## Product Change Notice (PCN)

**PCN Number: PCN-65690916R-01**

Product(s) Affected: V78-500-SMT series and V78-1000-SMT series (including SMT-TR configurations).

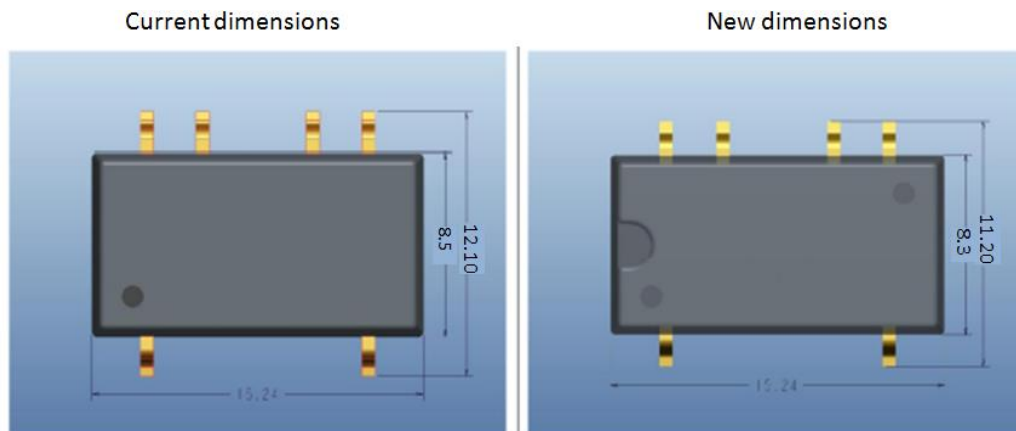
Description of Change: The V78-500-SMT and V78-1000-SMT series have been updated with minor changes in packaging to accommodate manufacturing process improvements.

The primary changes are to package width from 8.50mm to 8.30mm (including pins changed from 12.10mm to 11.20mm).

The new design will be distinguished with a semi-circle for the pin-orientation marking.

Additional Information: Existing PCB layouts should not be affected by the change. Testing has shown backward compatibility to the current recommended PCB layout.
